1.0 Executive Summary

The purpose of this report is to review and assess the conceptual layout and mode of construction for the on-airport segment of the proposed Automated People Mover (APM) at Fort Lauderdale-Hollywood International Airport. The report focuses on the following four areas of interest:

4.0 Review of Automated People Mover Conceptual Support Structure at Rental Car Facility (RAC)

FIGURE 7
TYPE "C" BENT
TYPICAL BENT SUPPORTING
FUTURE APM ONLY
(BENT 5A)

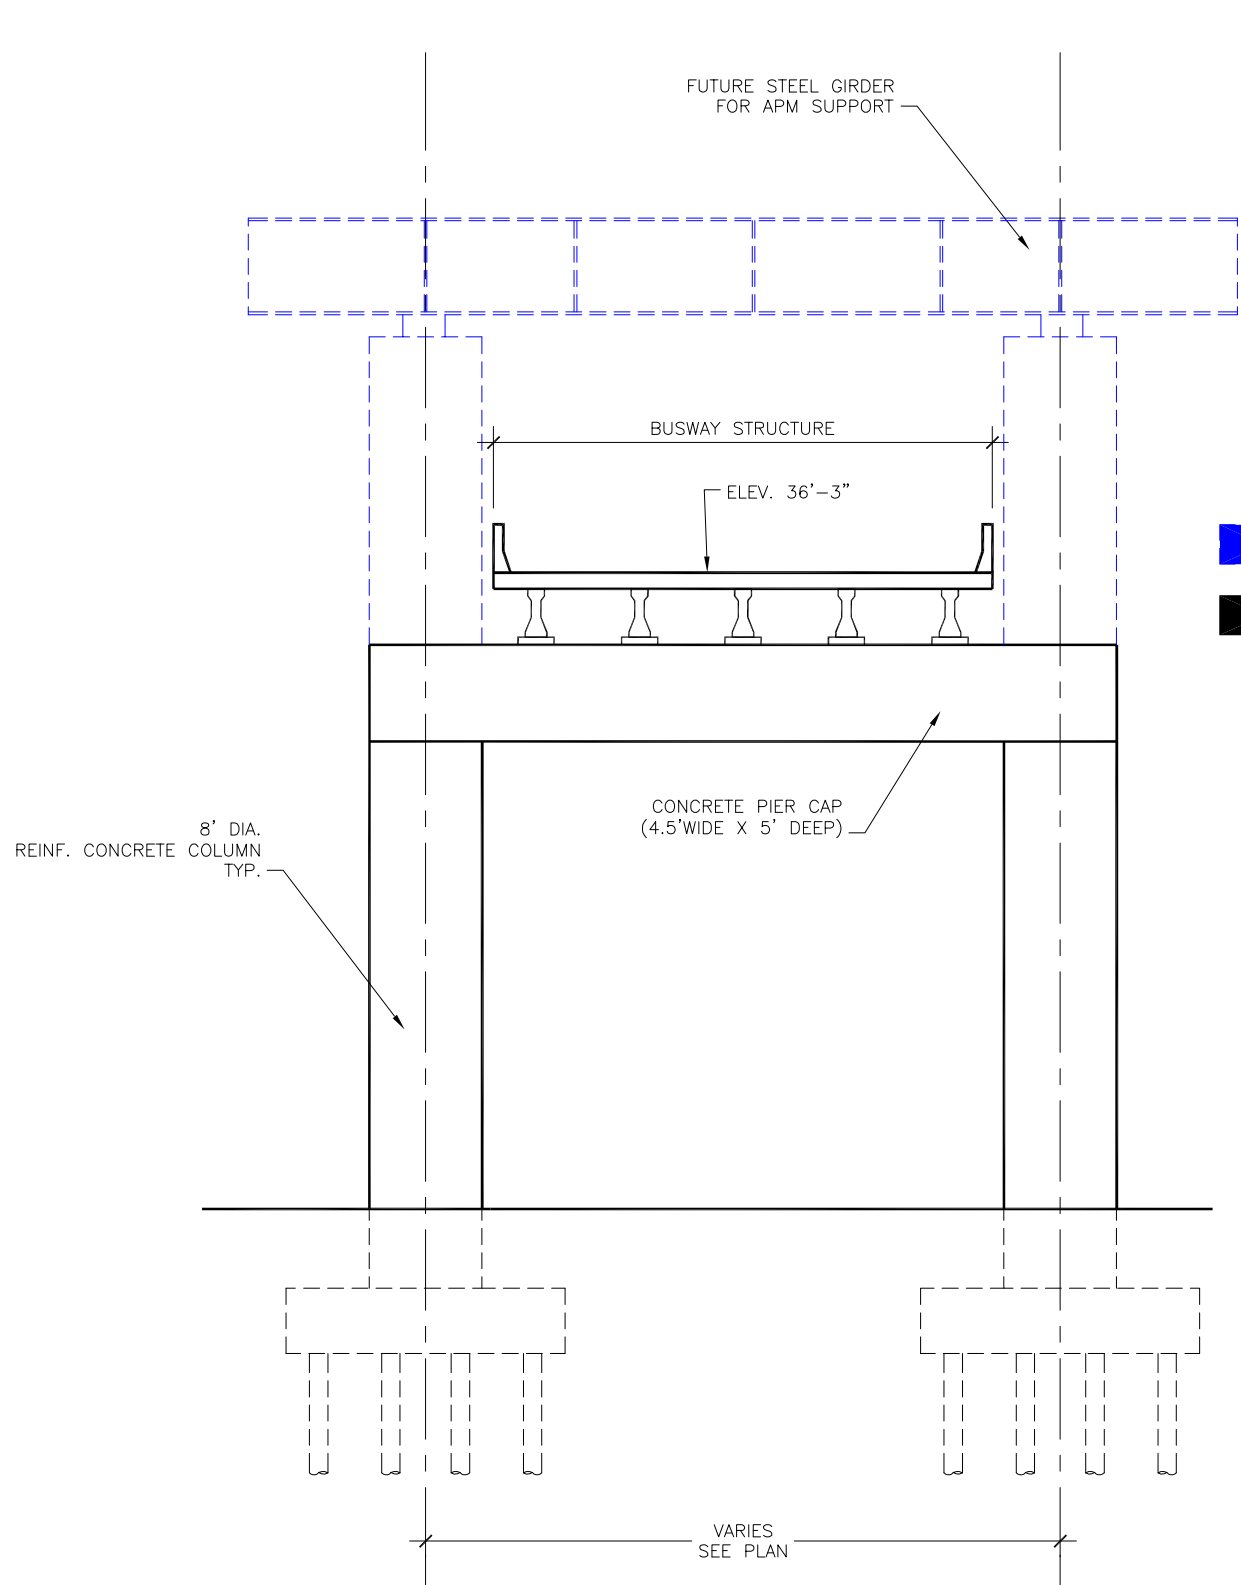
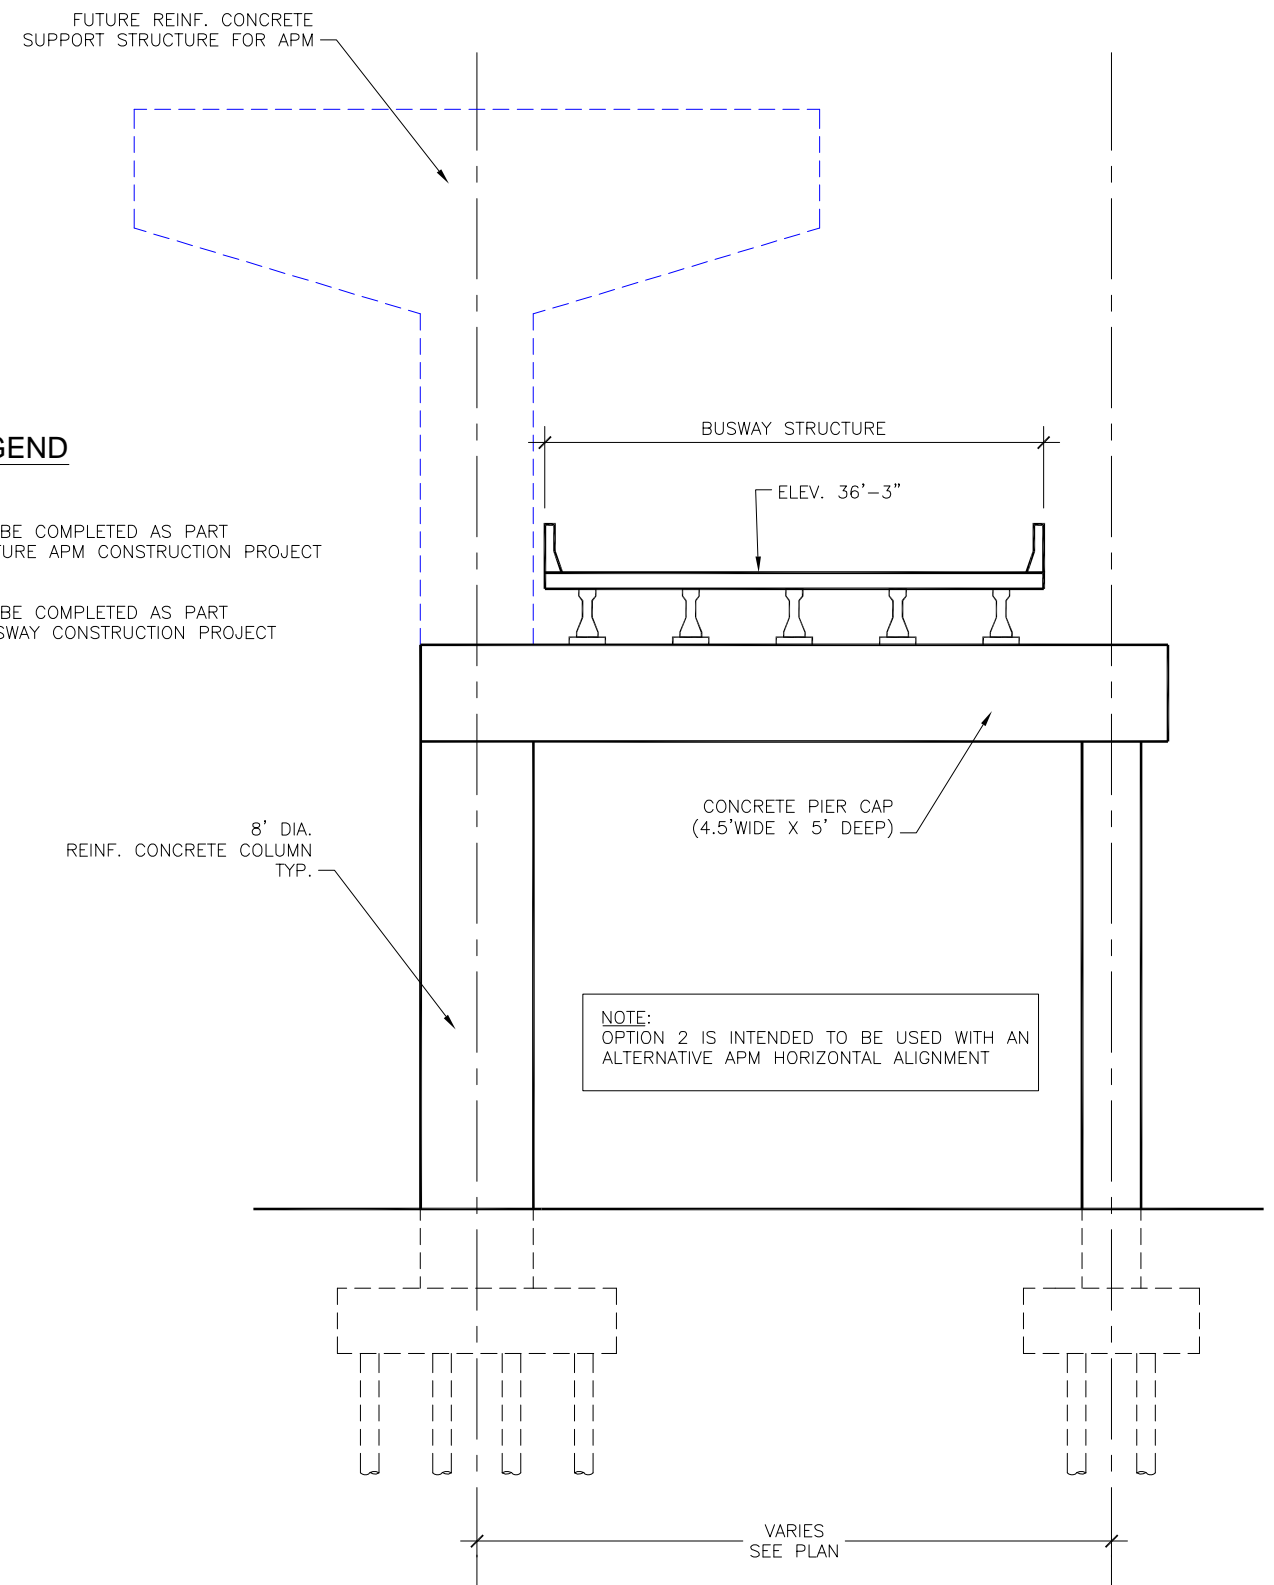
In the above analysis the columns require sixteen (16) auger cast piles of 250-ton capacity. The proposed size of foundations is 16' x 16'. Hence the thirty (30) piles proposed in the report submitted by EAC Consultants seems to be in excess. A possible reason for this is that the highest reactions developed anywhere along the proposed alignment was used for the design of all the foundations. This would be consistent with our analysis for the bent type shown on Figure 7 where a single column with a cantilever beam carries two APM guideways.

The EAC design calls for the single column bent with cantilevered beam to be used at the location just West of bent 5. Our analysis has indicated that due to the eccentric loading at this bent the superstructure as well as the foundations required would be excessively large. This would make the construction of this type of bent undesirable from both economically as well as from a constructability standpoint. There are two options for accomplishing this. The first one is to construct a portal frame, which will carry both the Busway and the APM loads as shown on Figure 8, Option 1. The plan layout for this option is shown on Figure 3. The second option is to shift the APM alignment further South in order to eliminate the eccentricity of the bent (Figure 8, Option 2). The second option would only require that one column be extended in the future for support of the APM guideway. The plan view of Option 2 is shown on Figure 3A.

FIGURE 8
 TYPE "D" BENT
 SUGGESTED BENT TYPE SUPPORTING
 BUSWAY AND FUTURE APM
 (BENT 3 AND 5)

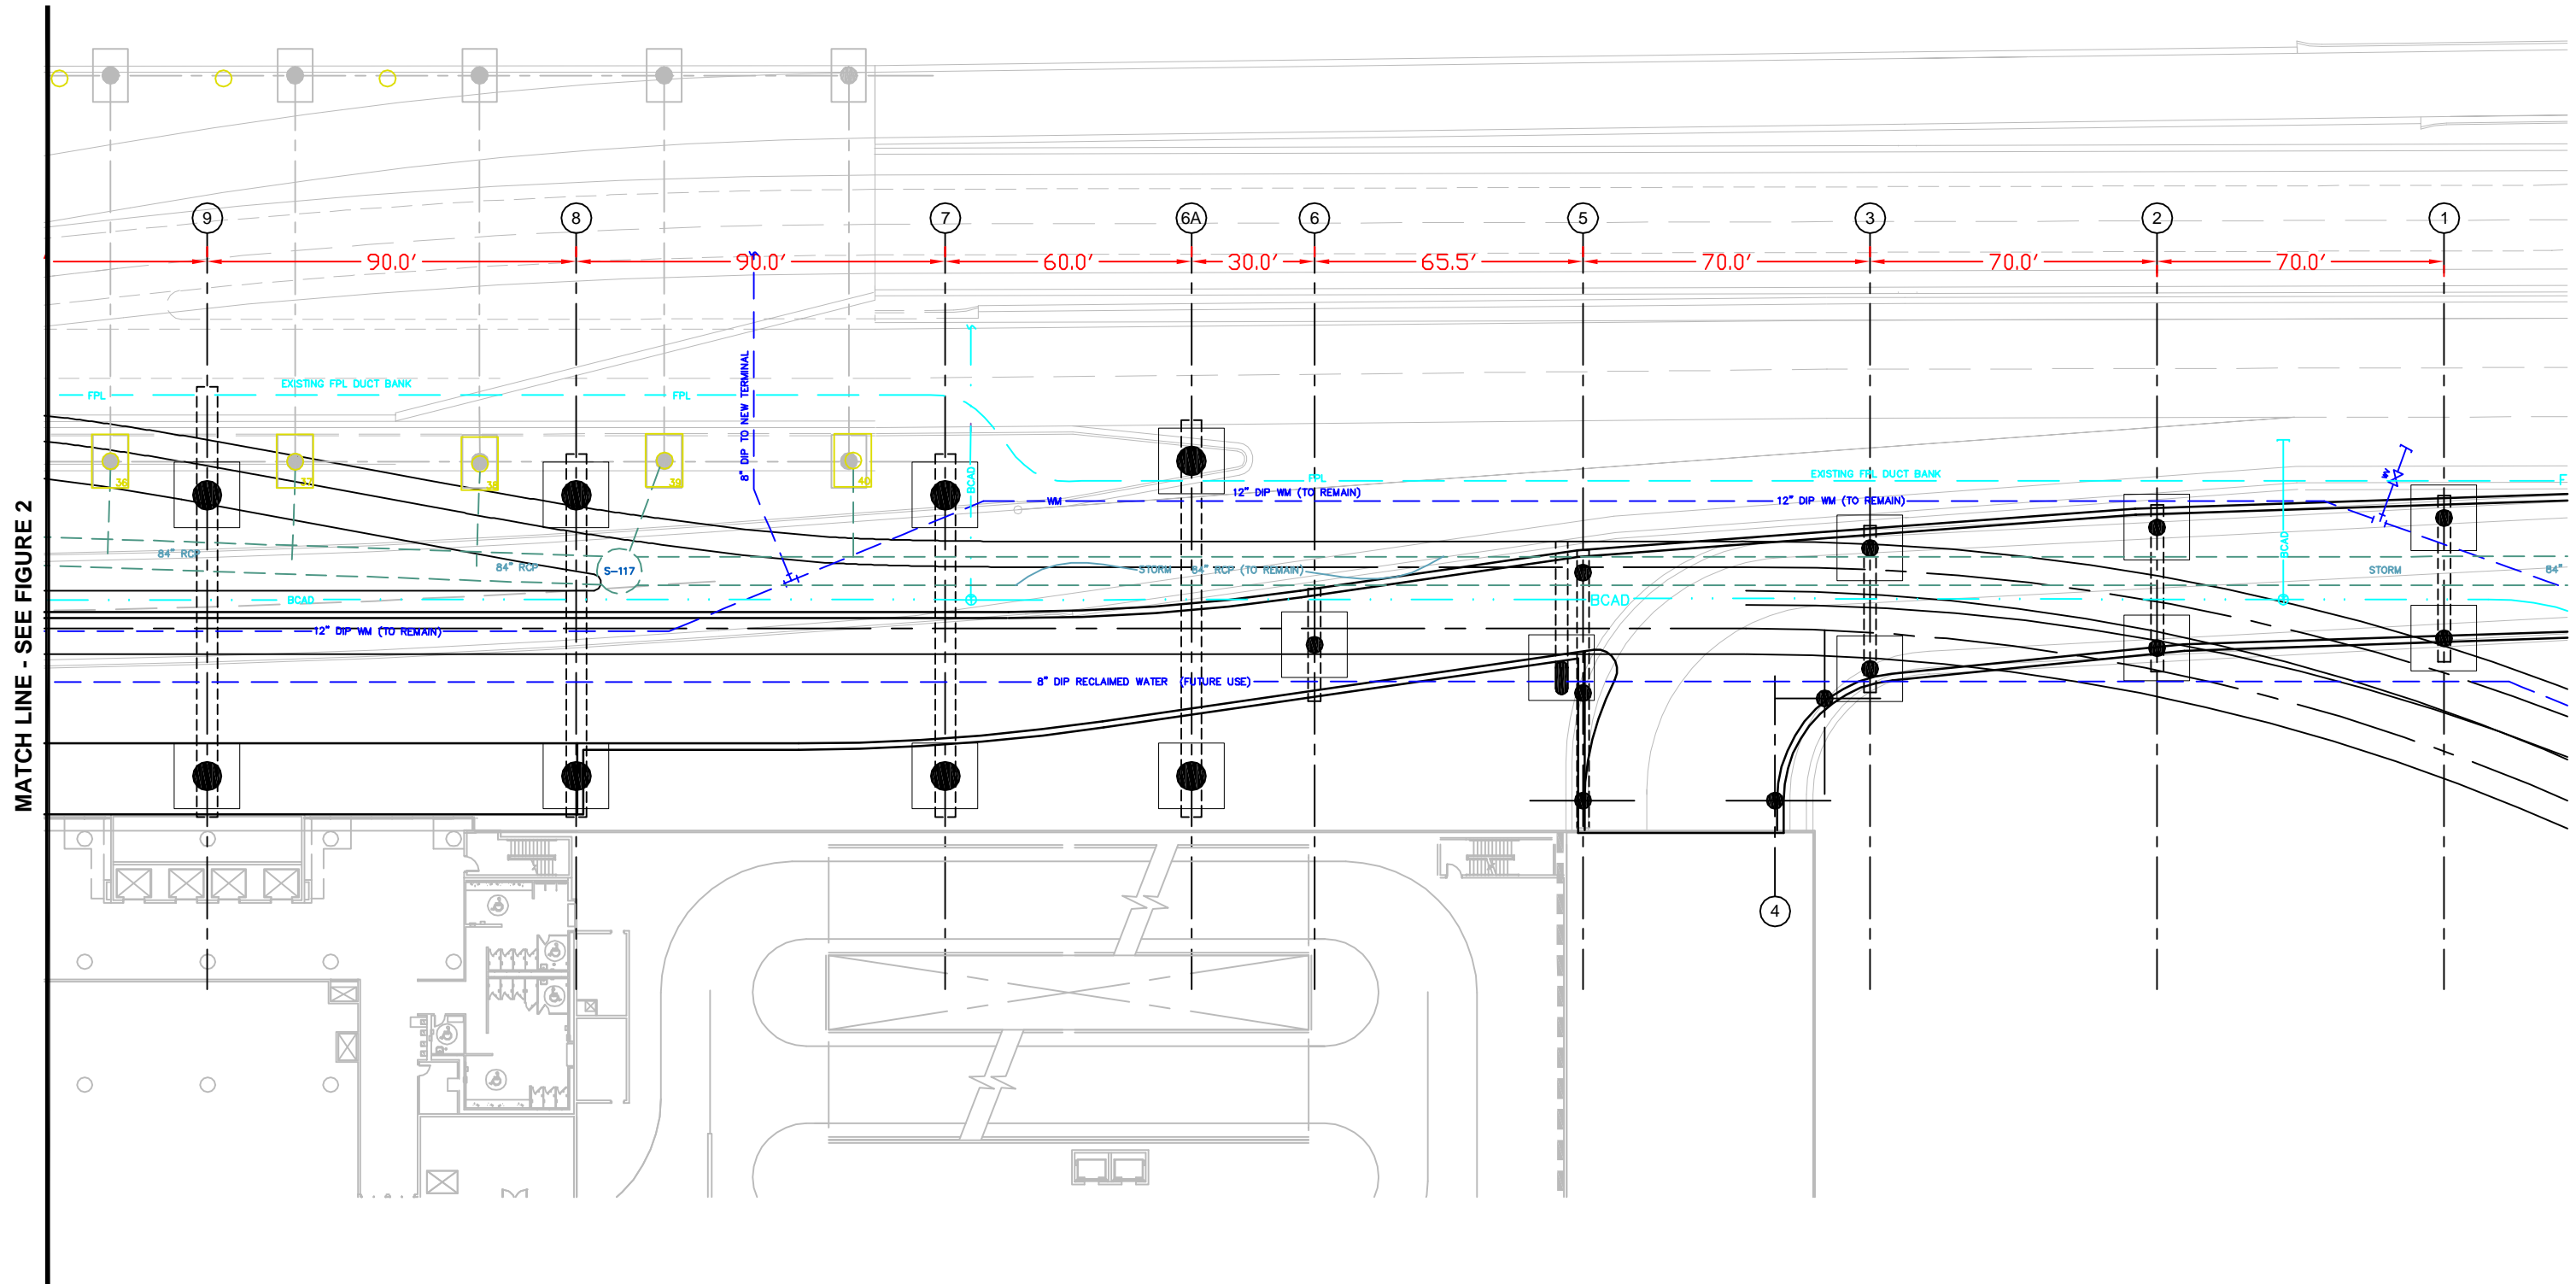
The EAC design also calls for bents 1, 2, 3 and 5 to only carry Busway loads. Due to the fact that the horizontal alignment of the APM guideway falls virtually on top of the Busway at bents 3 and 5, we believe that a combined bent would be more desirable option (See Figure 3). This would reduce the future construction cost of the APM as well as reduce the impact that future construction would have on the operations of the Airport.
